CONSTRUCTION DOCUMENTS  
GRANDVIEW RESERVE FILING NO. 1  
4 SITE INVESTMENTS, LLC (D.R. HORTON)  
SF-22-XXX  
EASTONVILLE RD & REX RD  
EL PASO COUNTY, FALCON, CO 80831

OVERALL SHEET

**C1.10**  
 Sheet 15 of 29

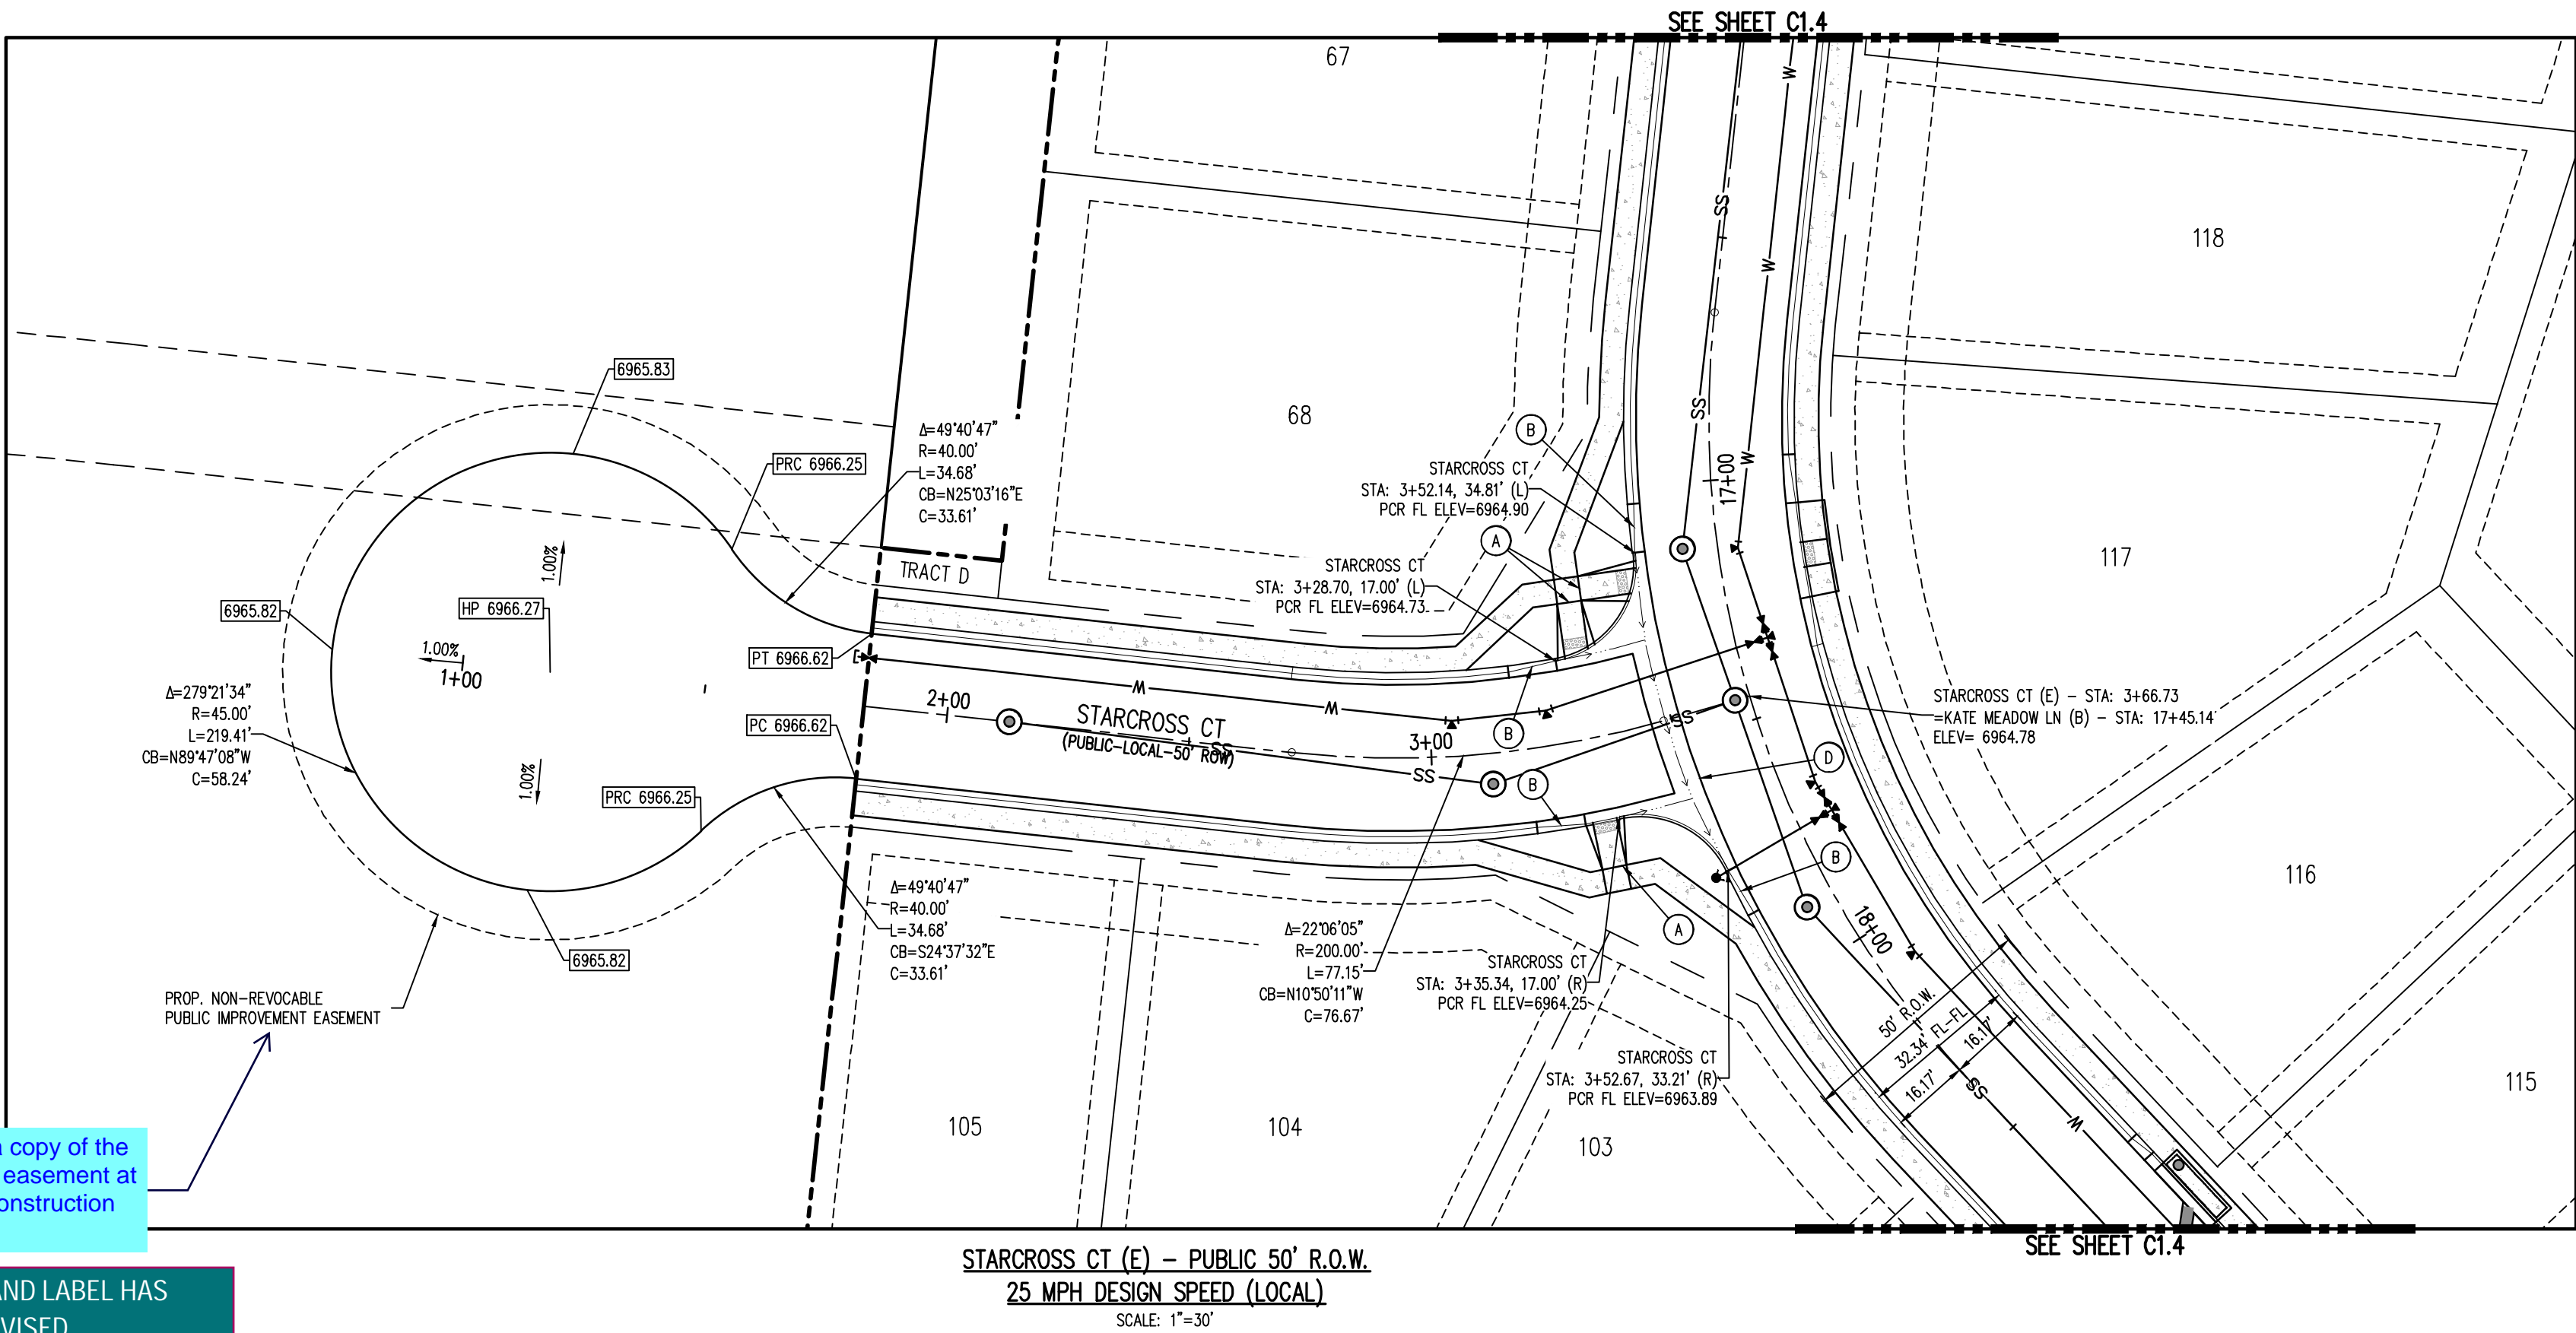
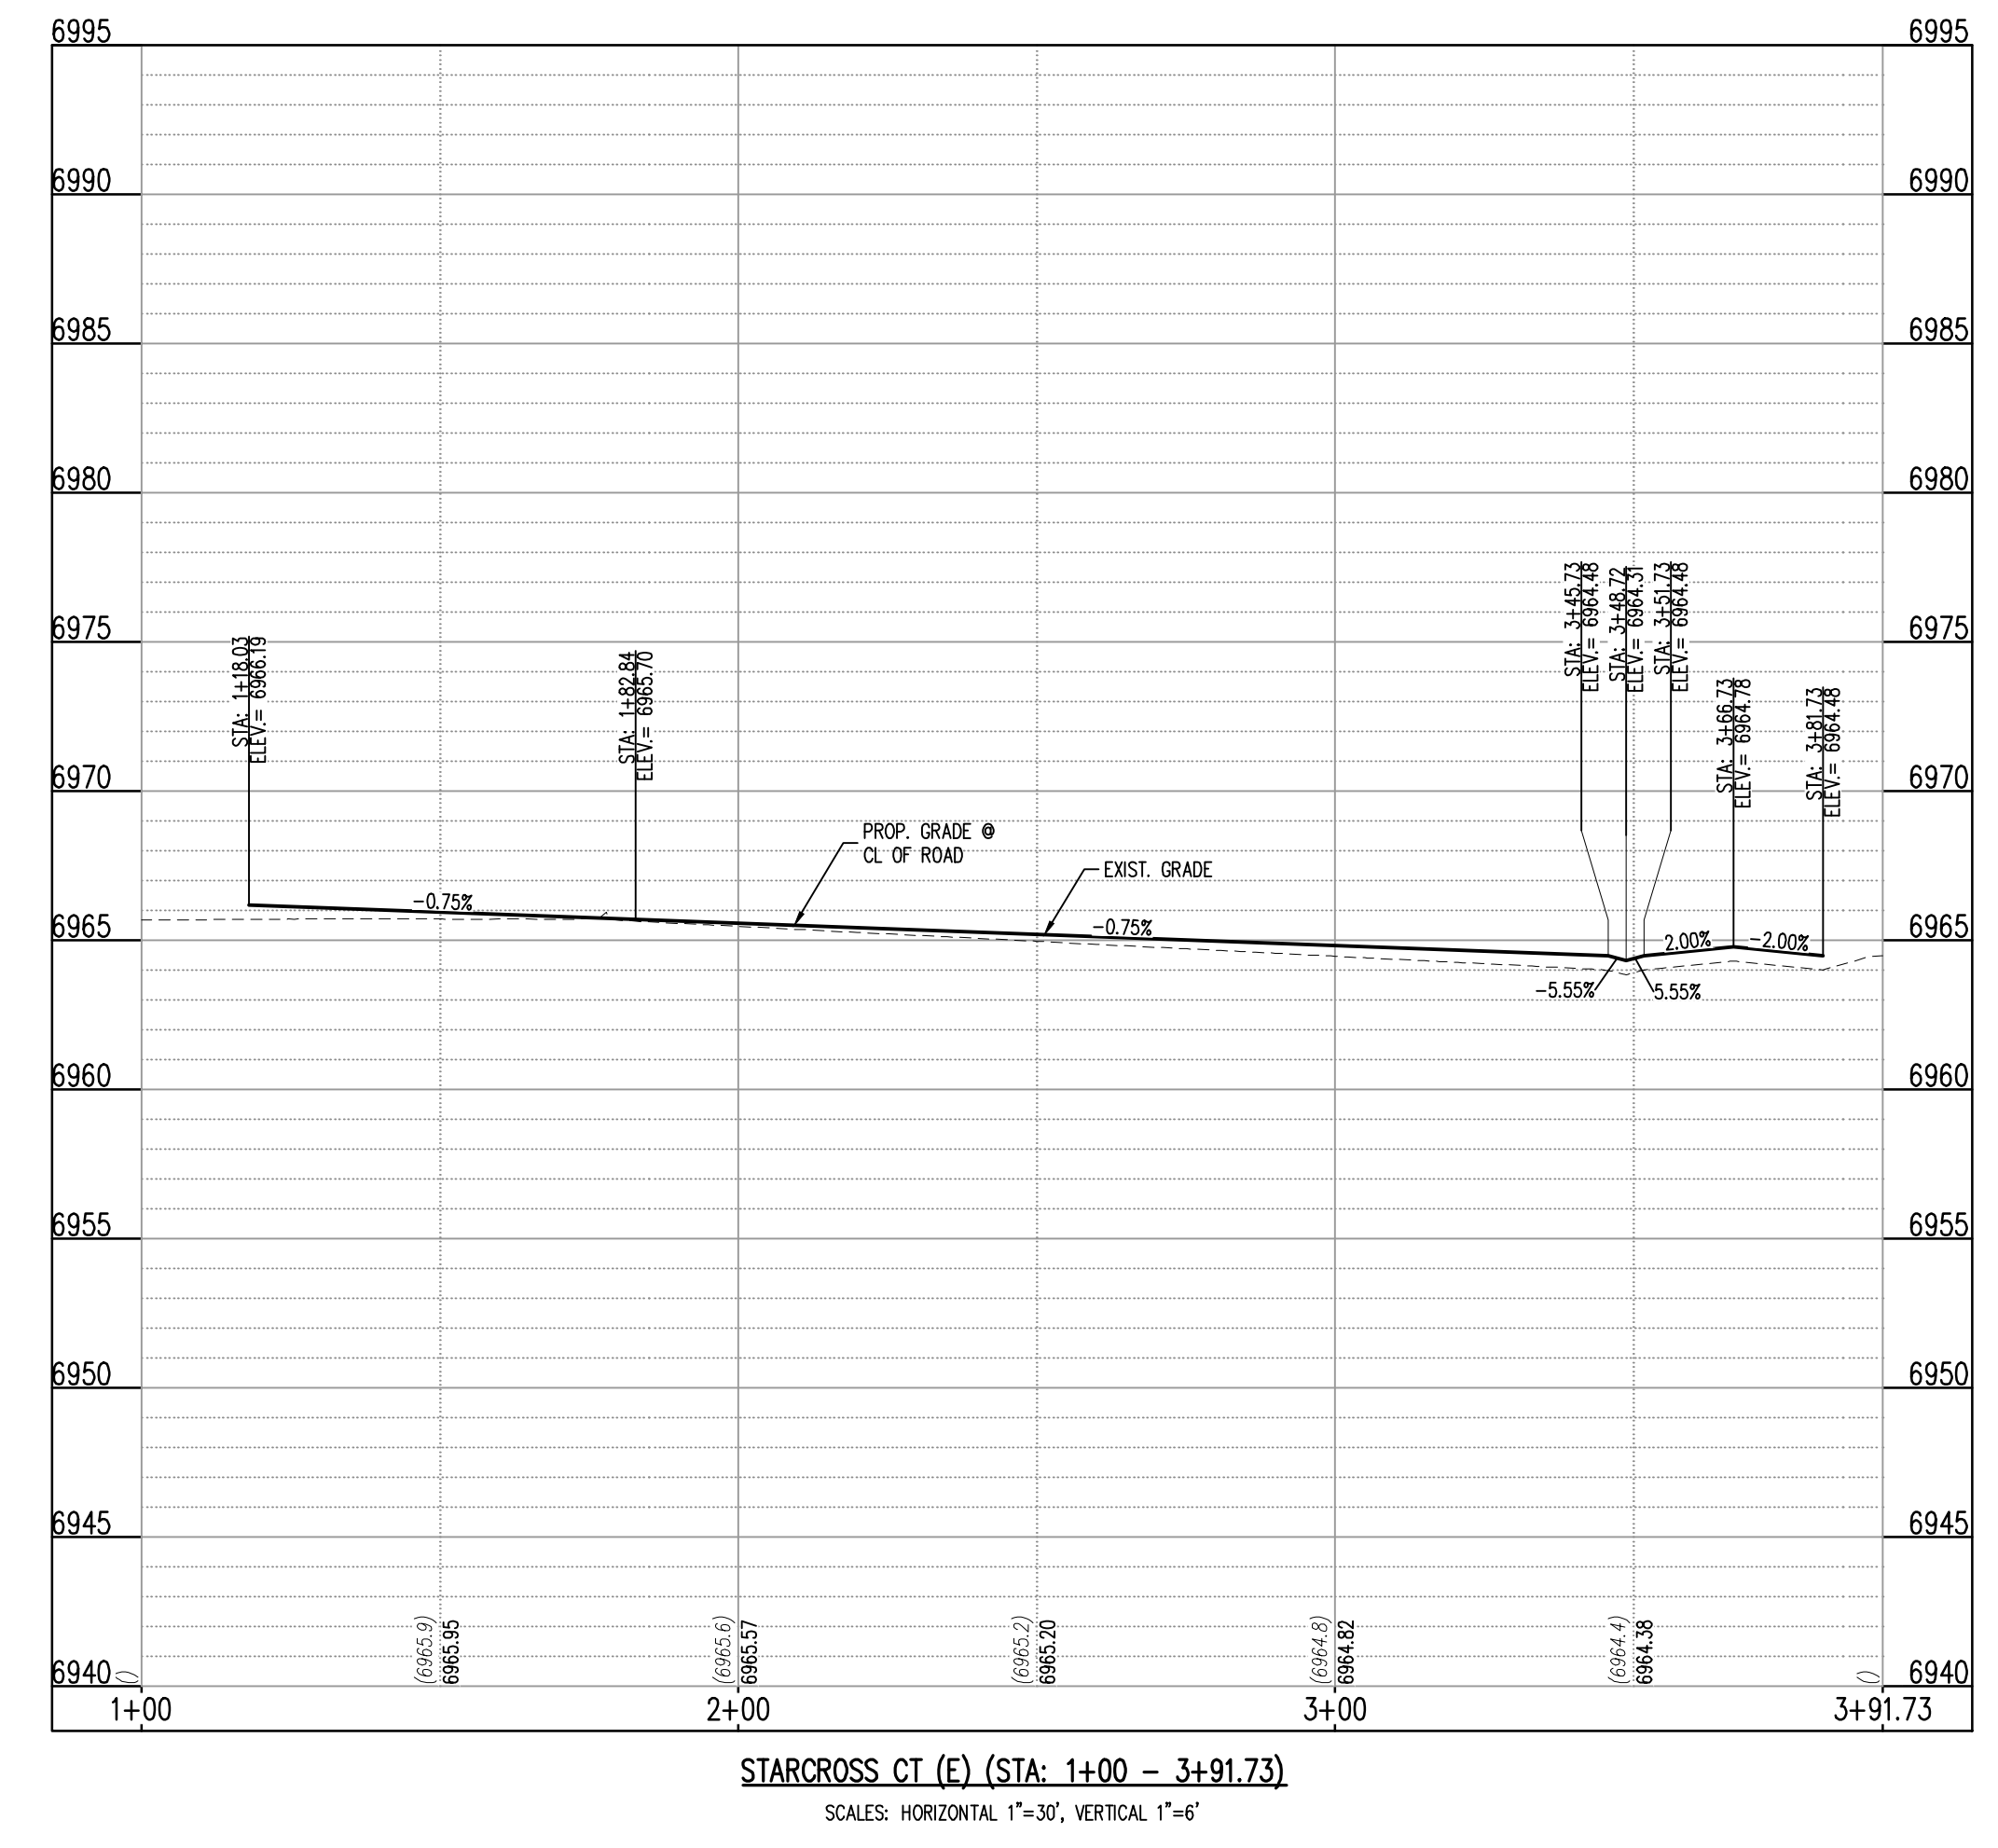
Provide a copy of the recorded easement at the pre-construction meeting.

NOTED AND LABEL HAS BEEN REVISED
